TO: City Council
FROM: City Manager and Staff 
DATE: October 26, 2007
SUBJECT: Supplemental Report Concerning the Proposed Improvements at Forum & Stadium

Subject: Columbia Non-Motorized Pilot Program Intersection Designs
Stadium Boulevard and Forum Boulevard
City Project Nos. NMT 2006-0001
Federal Aid Project No. CPP-9999(502)
Response to a Letter of Inquiry

RE: Review of Preliminary Plans of Stadium and Forum Intersection

Re: Columbia, Missouri NMT Intersections – CPP 9999(502)

STADIUM BLVD. & PROVIDENCE RD.
PLAN

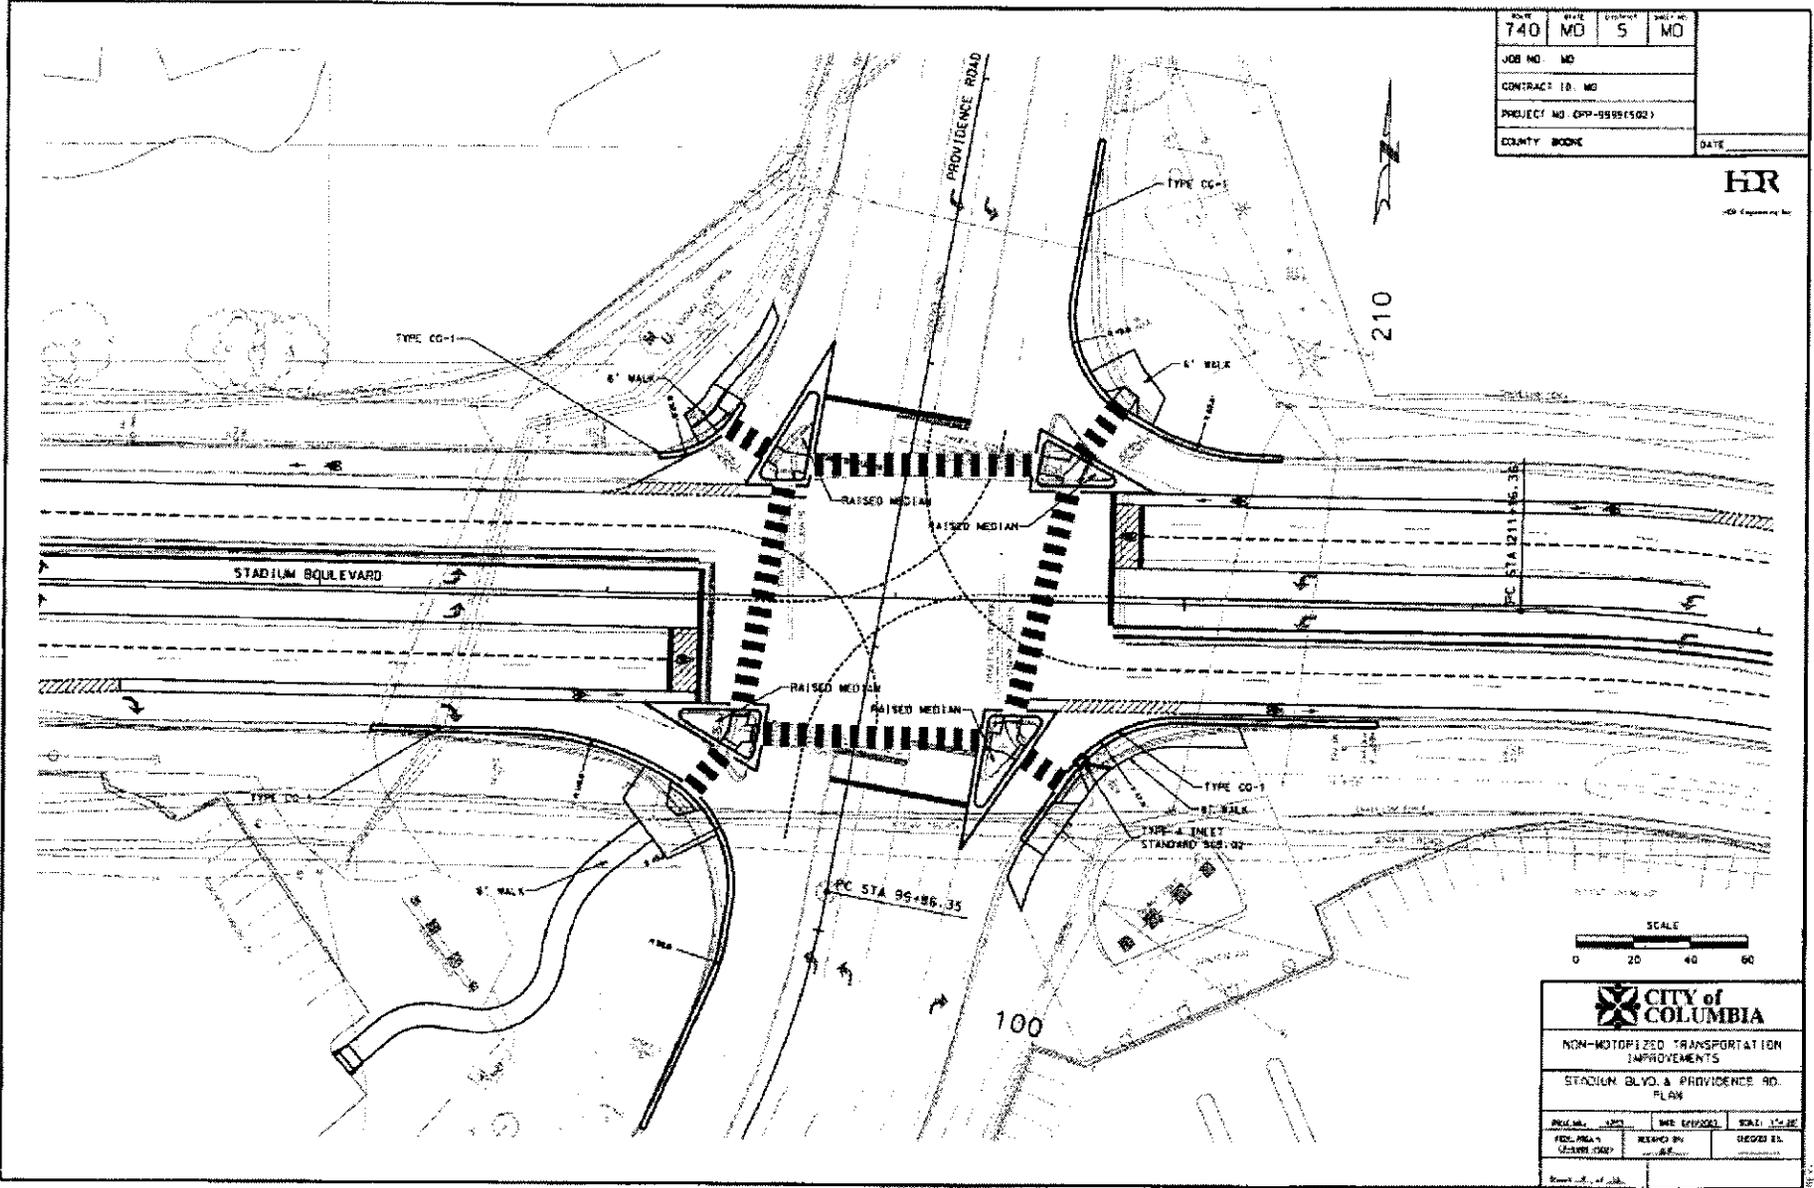
- Signal heads need to be labeled on plans (RYS, RYL etc)

CITY of COLUMBIA		
NON-MOTORIZED TRANSPORTATION IMPROVEMENTS		
STADIUM BLVD. & FORUM BLVD STRIPING PLAN		
PHD: M.J.	CHK: K.L.C.	DATE: 12-20-20
APP: M.A.	DESIGN BY: J.L.	DRAWN BY: J.L.
Sheet: 11-21	PLAN	100.1

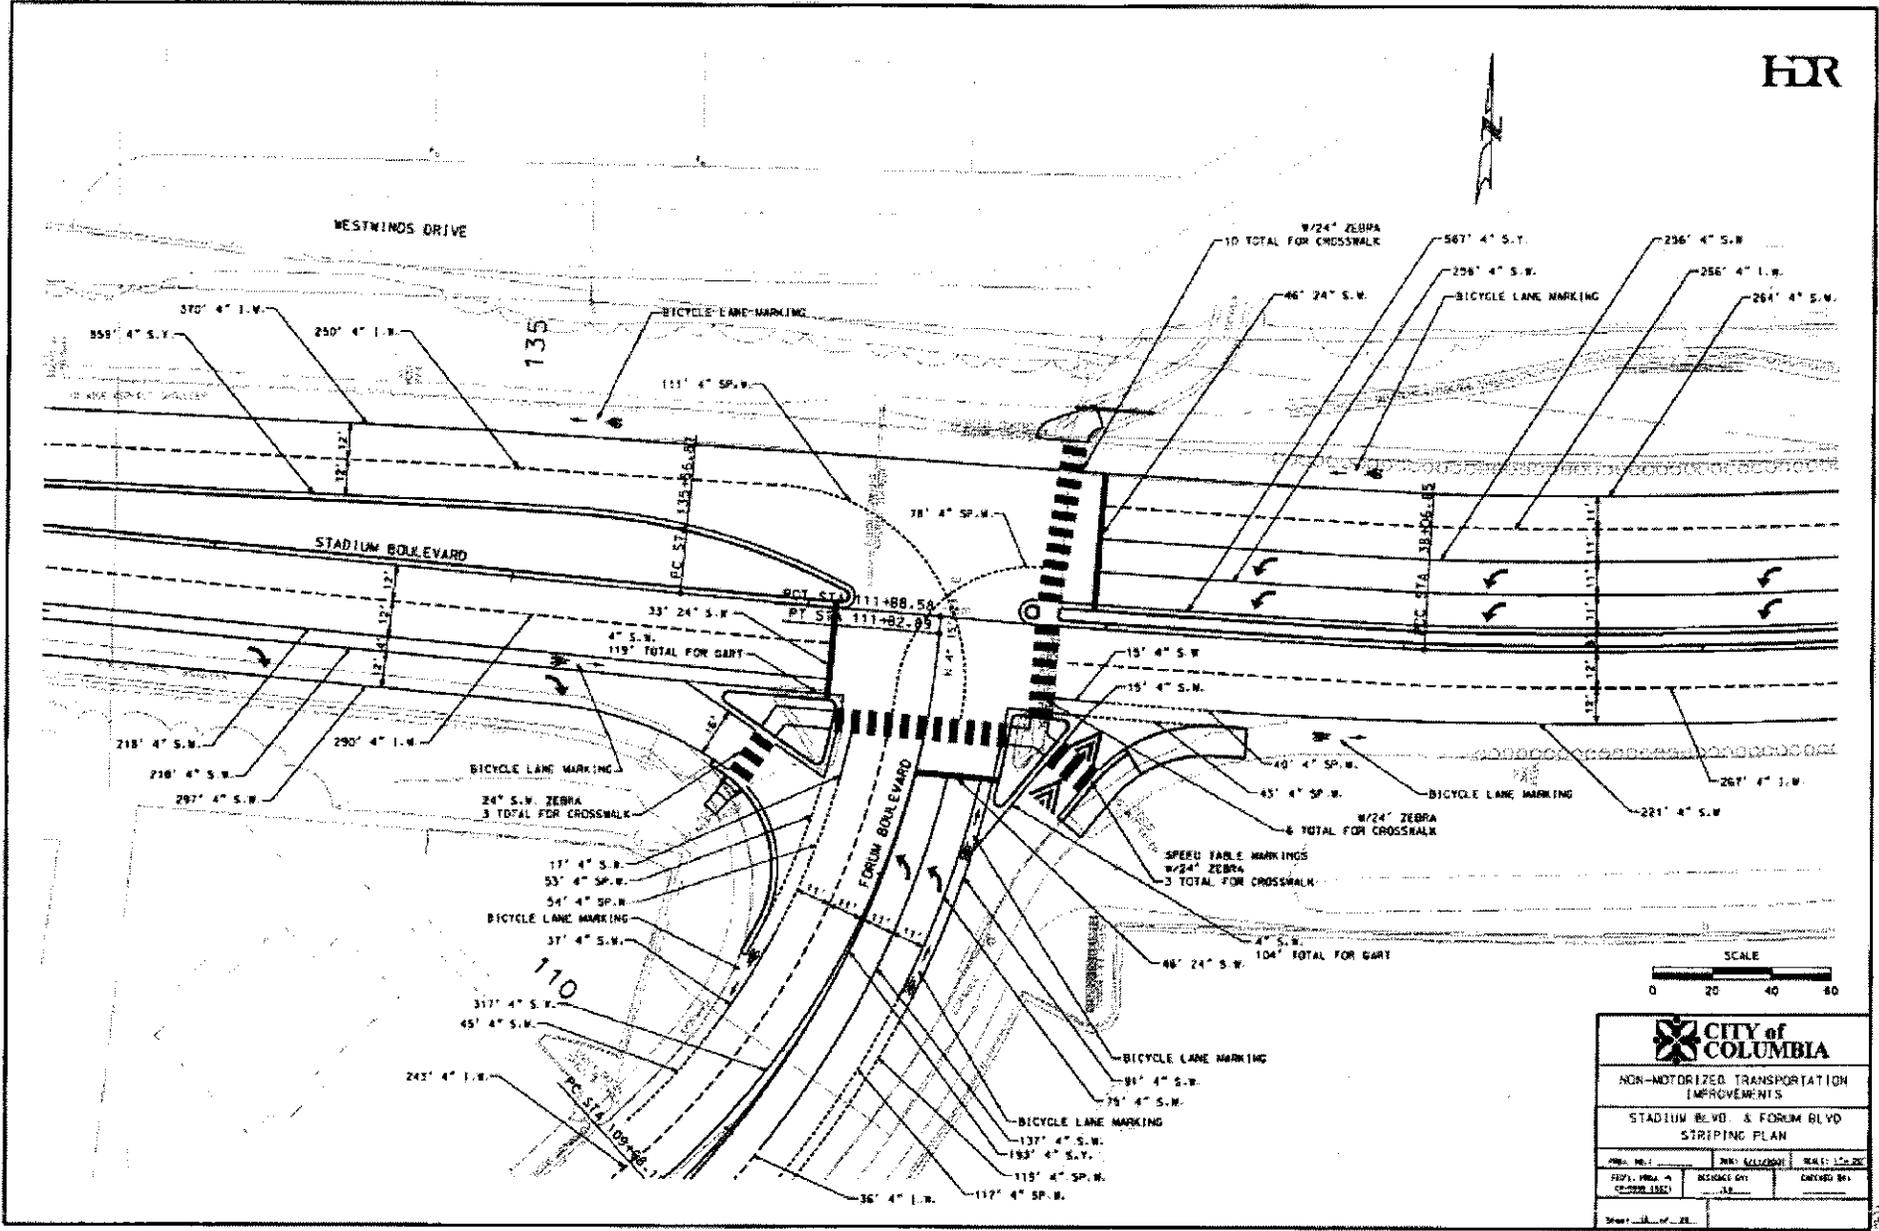
We have recently reviewed the preliminary plans for changes to the Stadium and Forum intersection as submitted to MODOT and the City of Columbia on June 11, 2007. We are surprised that the plans are this far along without any communication from the City or the Consultant to the stakeholders informing us of the proposed revisions to this intersection. We find the following design elements to be of particular concern:

1. Reducing the width of drive lanes to 11', especially on a 50 mile an hour road to create a situation where vehicles will be transitioning from 12' to 11' at great speeds.
2. Reducing the overall width of the intersection, thereby choking down the available room for turning movements and prohibiting trucks from making the various turns without encroaching into the adjacent turn lane.
3. The use of "Australian right turns", thereby negatively effecting truck traffic.

- Need more information at post 3A & 4, unclear as to what is intended for pedestrian fixtures (signal and signing)
- How are the bike zones to be detected? Loops, video? Any addition of detection equipment needs to be added to plans
- Existing condition and proposed elements are nearly impossible to differ between.
- Would prefer a 3 head signal at 3A with another signal in the median
- Use of existing conduit may not be possible due to present conduit being full or collapsed

FORUM BOULEVARD
Forum

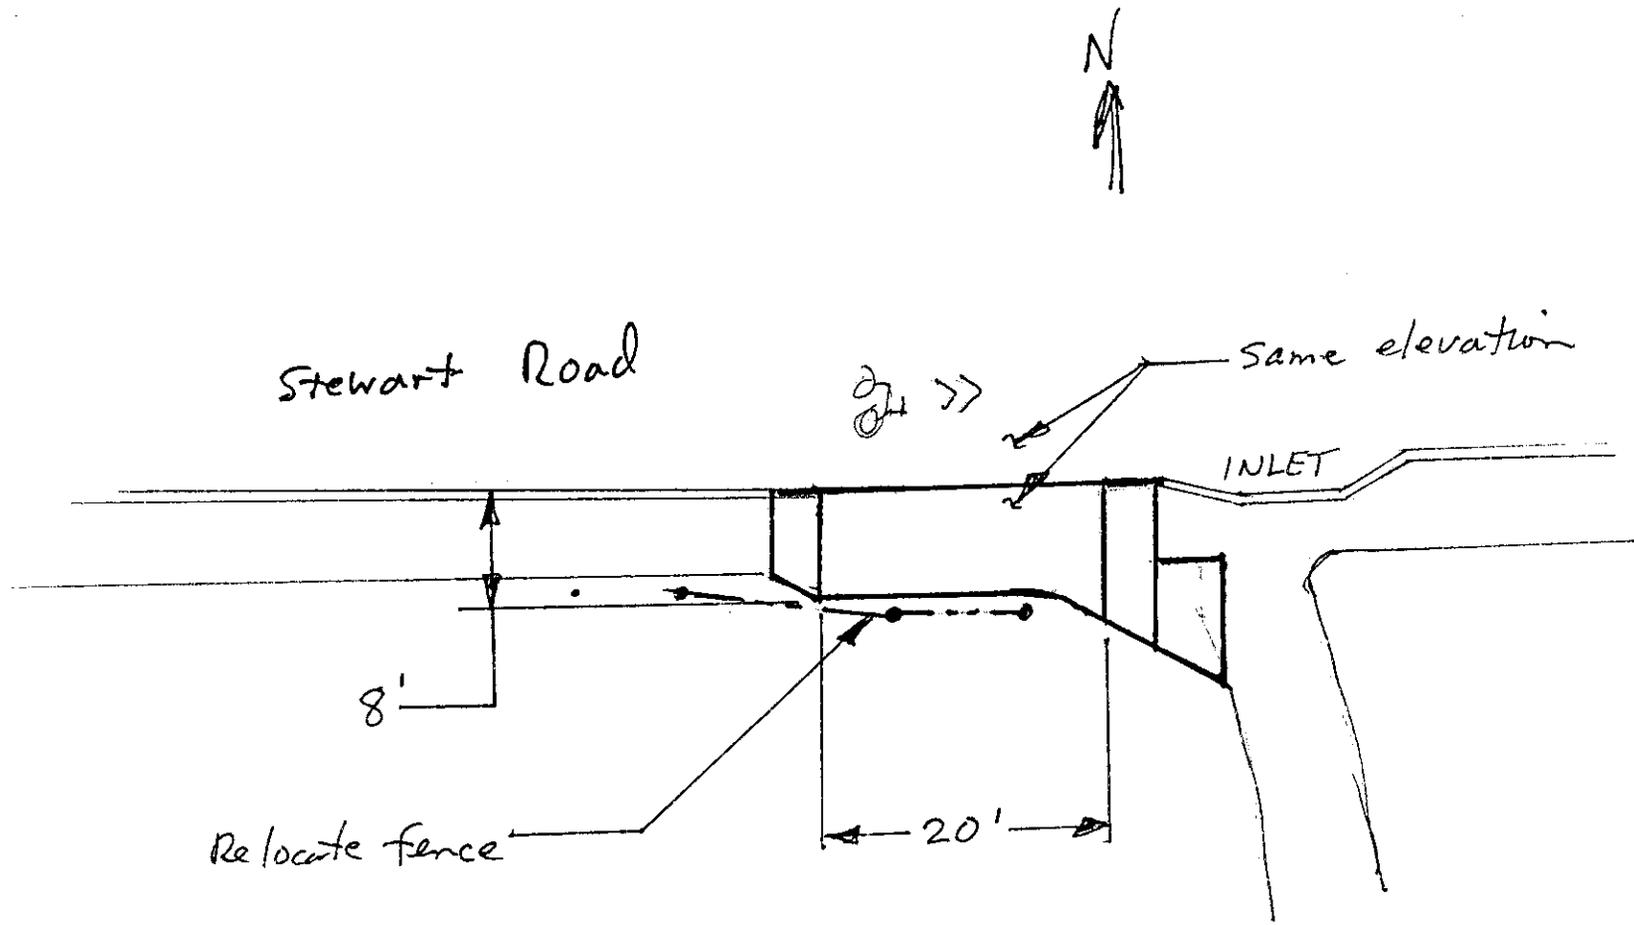
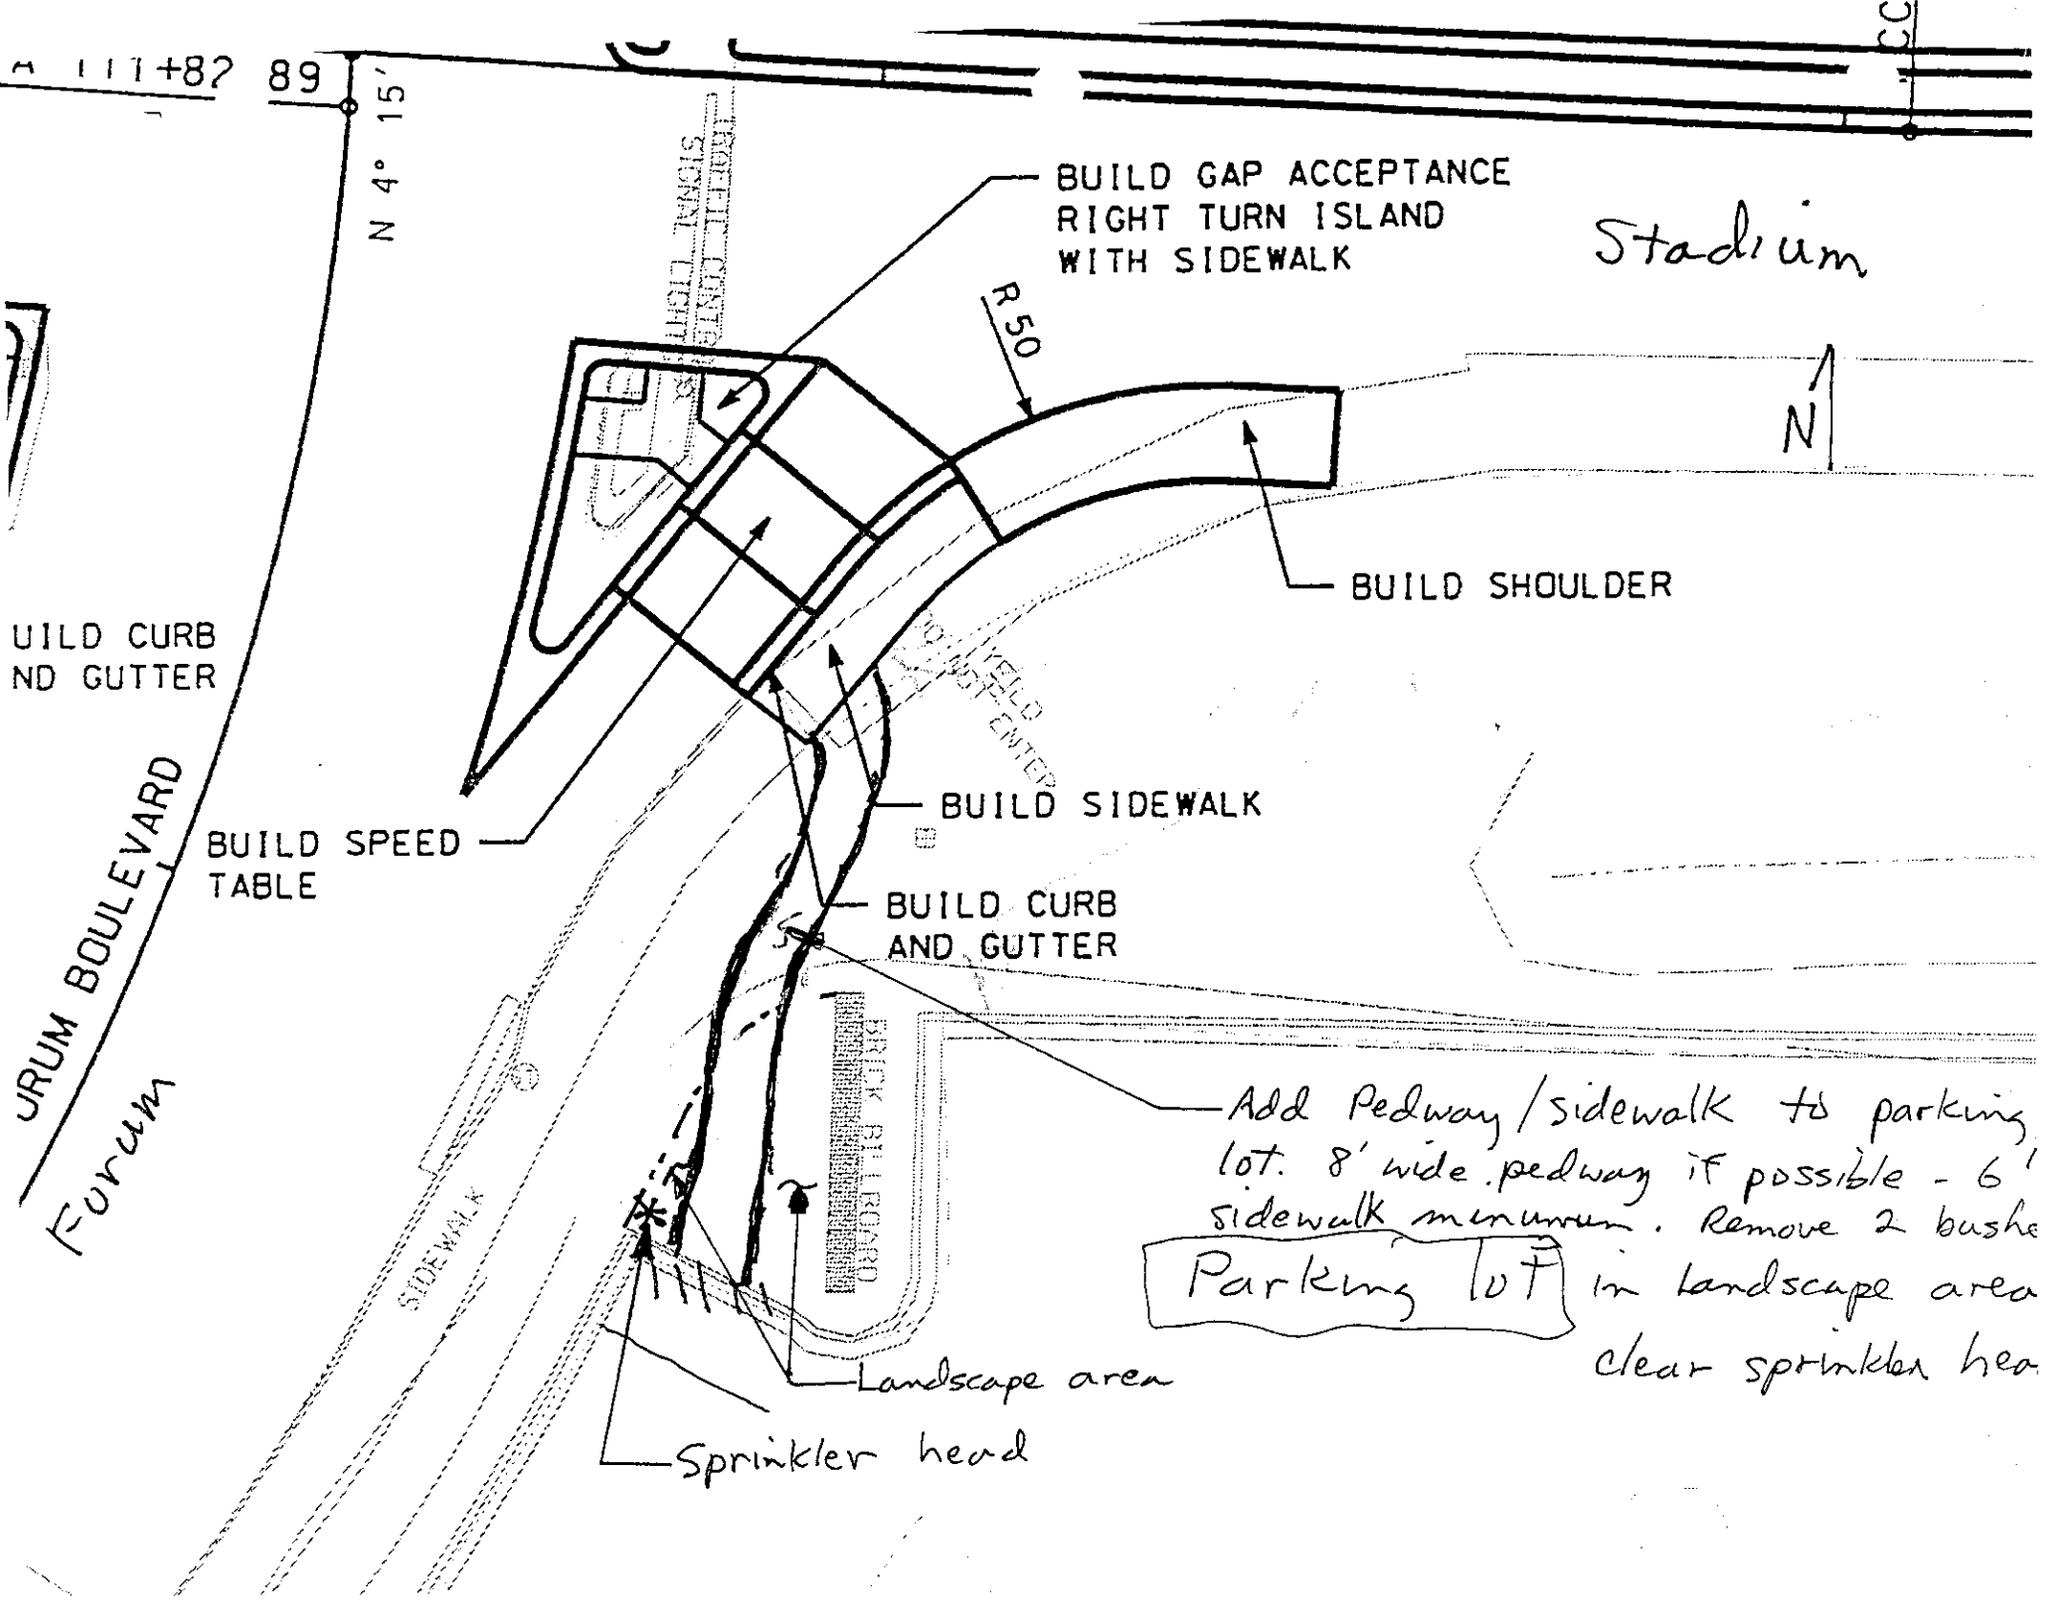
3. Recommend that the location of the flat area be a minimum of one car length from Stadium. Additional interior opening for cycle turning desirable. Sketch of proposed set-up attached.

6. Add a 8' sidewalk connection from the sidewalk on the SW corner to the Schnucks parking lot, connecting to one or two spaces. Attached is a sketch of the general layout as discussed with the adjacent property owner. Adjustments for grades may be necessary to accommodate ADA requirements. Will need to be labeled as 'Not part of this project' due to acquisition time line.

SHIFT TABLE PORTION ~1/3'
SOUTH - PROVIDE 1 CAR LENGTH
FROM RAISED FLAT AREA TO
NOSE OF ISLAND

Expand bike-ped crossing area to minimize conflicts.

Add Pedway/sidewalk to parking
lot. 8' wide pedway if possible - 6'
sidewalk minimum. Remove 2 bushes
